**DEPARTMENT OF TRANSPORTATION
STATE OF GEORGIA
REVISED PROJECT CONCEPT REPORT**

Project Type: <u>Major</u>	P.I. Number: <u>122890</u>
GDOT District: <u>1</u>	County: <u>Clarke</u>
Federal Route Number: <u>US 78</u>	State Route Number: <u>SR 10</u>

This concept revision includes changes in lane layouts, lane widths, shoulder widths, driveway access, removal of bike lanes and updated traffic Volumes throughout the project corridor.

NH000-0003-03-(053) - CLARKE, P. I. NO. 122890
SR 10 LOOP AT ATLANTA HWY INTERCHANGE
SR10 LOOP, JENNINGS MILL RD & HUNTINGTON RD
CURRENT LAYOUT AS OF 8-31-2015

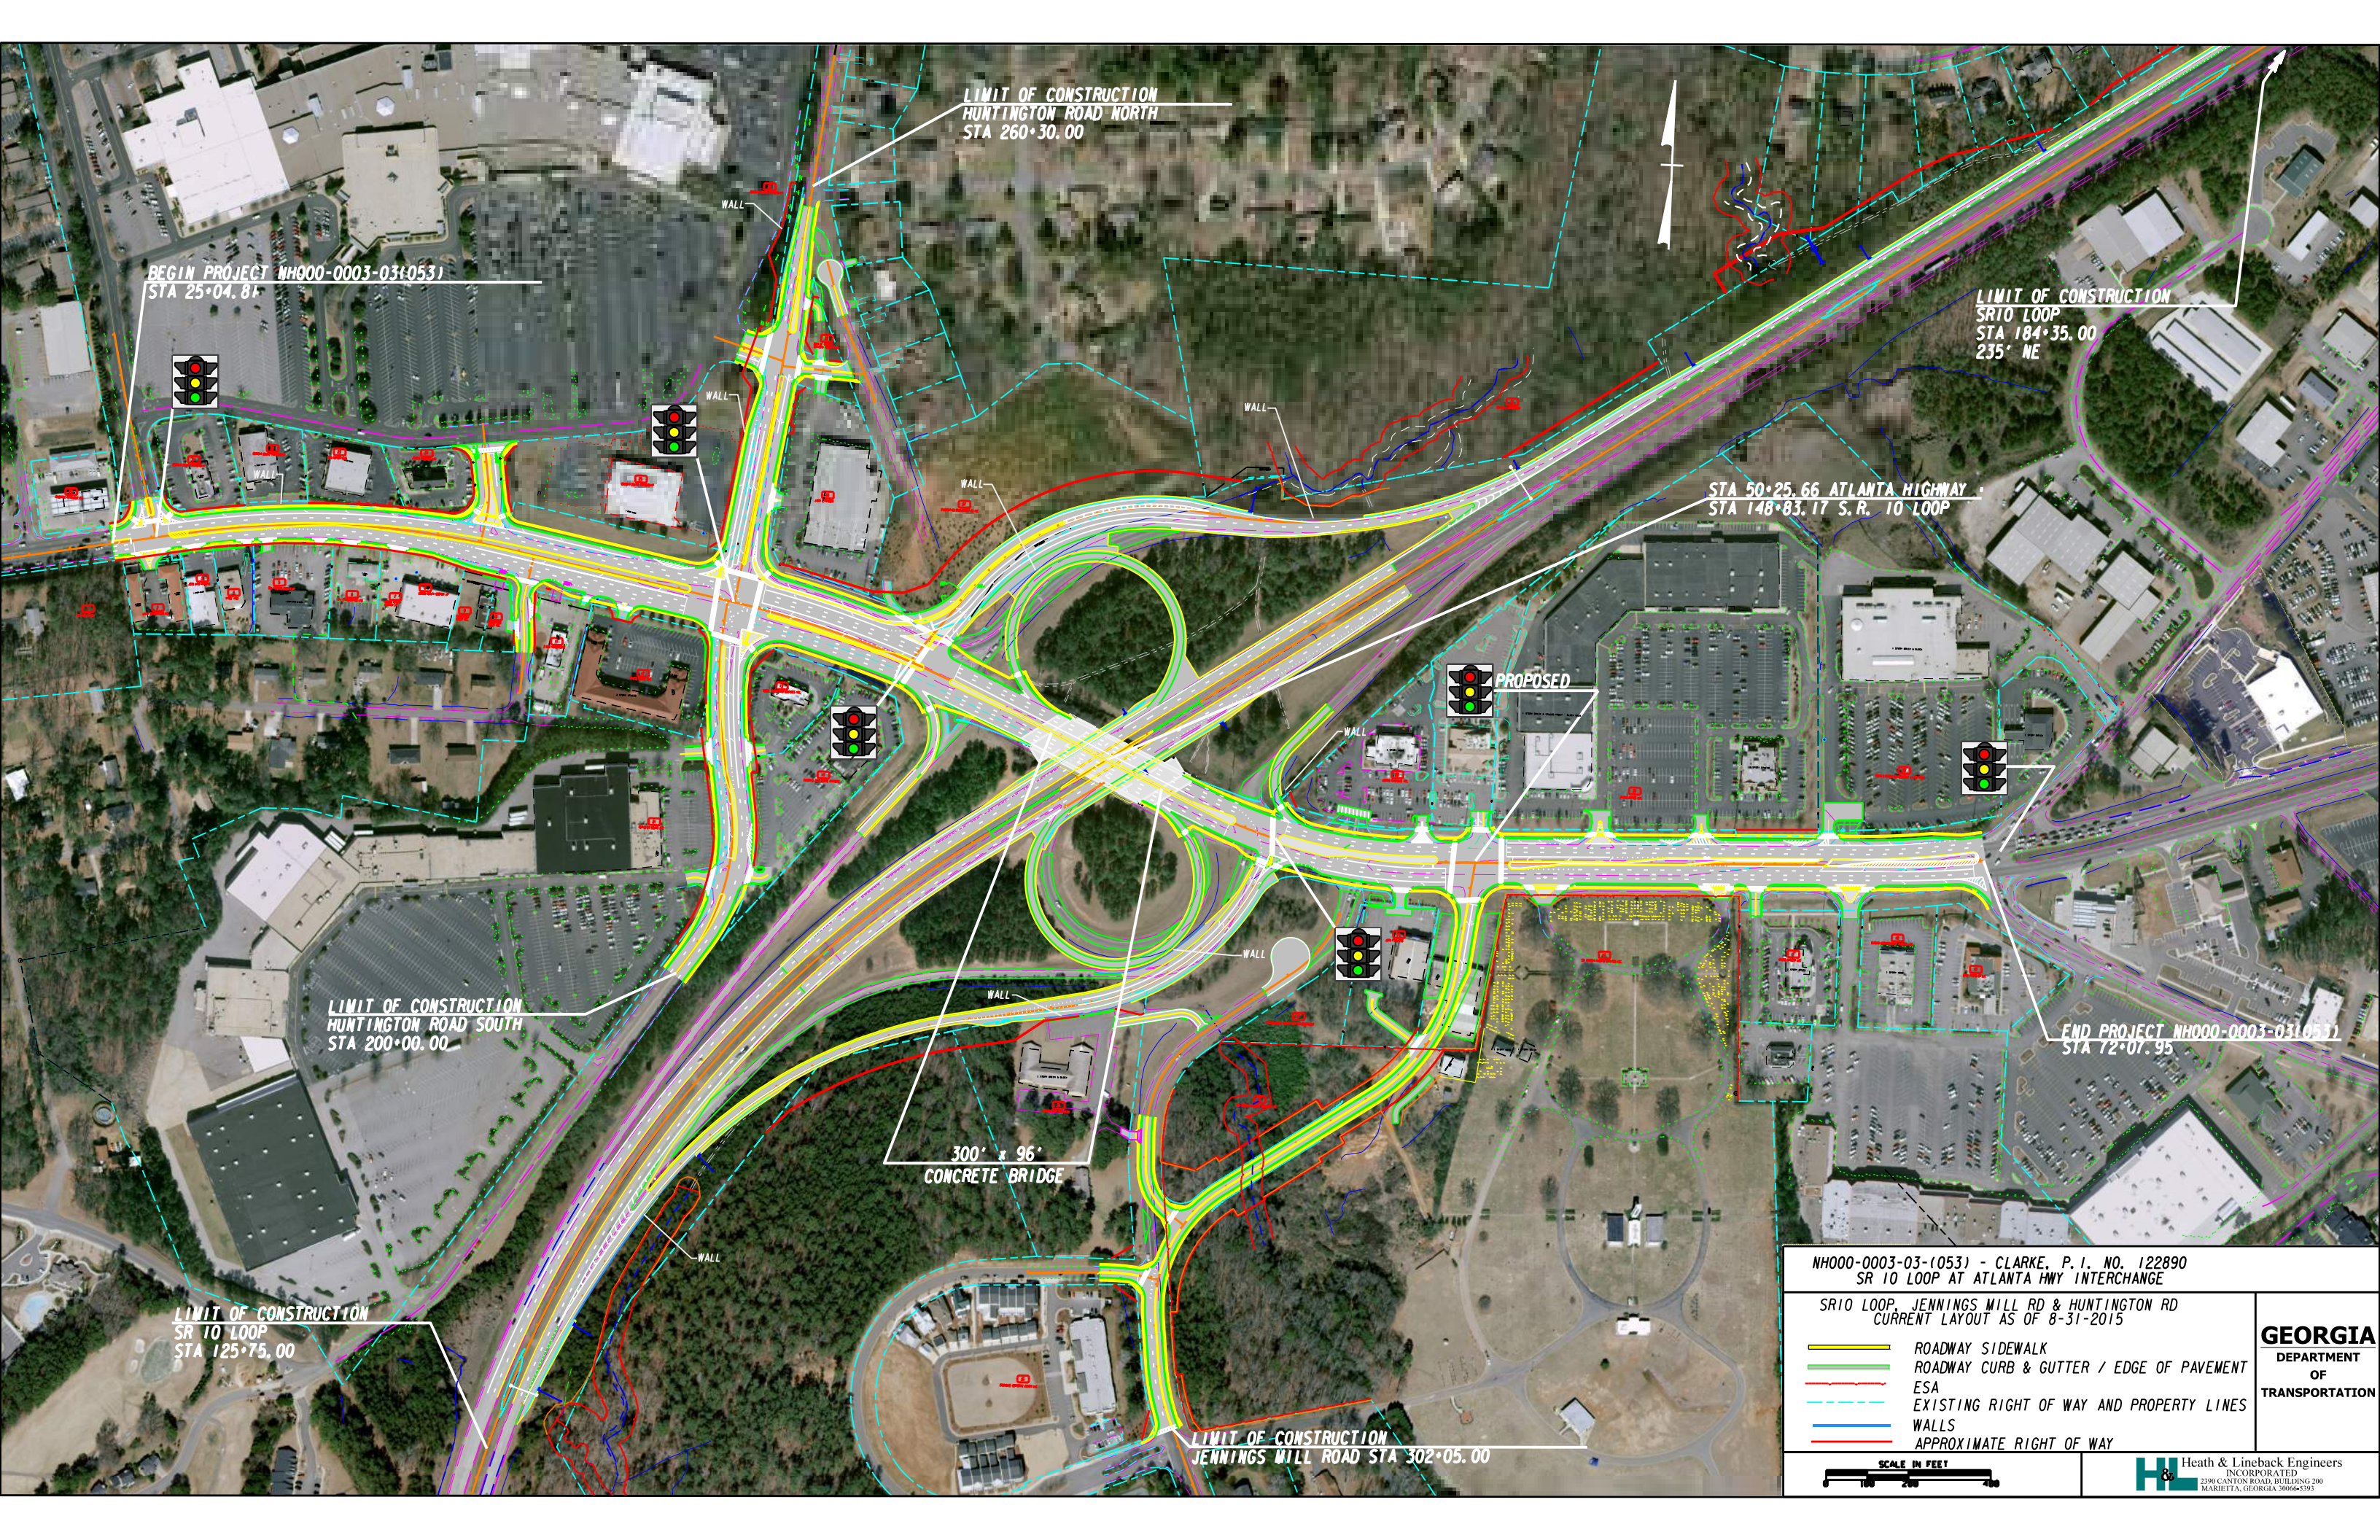
Approved Features:	Proposed Features:
<p>Typical Section (Atlanta Hwy):</p> <ul style="list-style-type: none"> • 12'-0" Lane Widths • 4'-0" Bike Lanes • 16'-0" Shoulders <p>Typical Section (Huntington Road):</p> <ul style="list-style-type: none"> • 16'-0" Shoulder <p>Typical Section (Jennings Mill Road):</p> <ul style="list-style-type: none"> • 16'-0" Shoulder <p>Project Concept Layout:</p> <ul style="list-style-type: none"> • 4 lanes in each direction through the interchange area 	<p>Typical Section (Atlanta Hwy):</p> <ul style="list-style-type: none"> • 11'-0" Lane Widths • No Bike lanes • 8'-0" to 16'-0" Shoulders <p>Typical Section (Huntington Road):</p> <ul style="list-style-type: none"> • 10'-0" Shoulder <p>Typical Section (Jennings Mill Road):</p> <ul style="list-style-type: none"> • 10'-0" Shoulder <p>Project Concept Layout:</p> <ul style="list-style-type: none"> • 3 lanes in each direction through the interchange area

<p>Reason(s) for change: ROW is the highest cost item on this project. Reducing the widths and shoulder widths will result in significant cost savings (pavement bridge and ROW) and also reduce / minimize the amount of new ROW required to construct the project. The bike lane would not tie to any proposed bike routes designated by GDOT or Athens-Clarke County.</p>
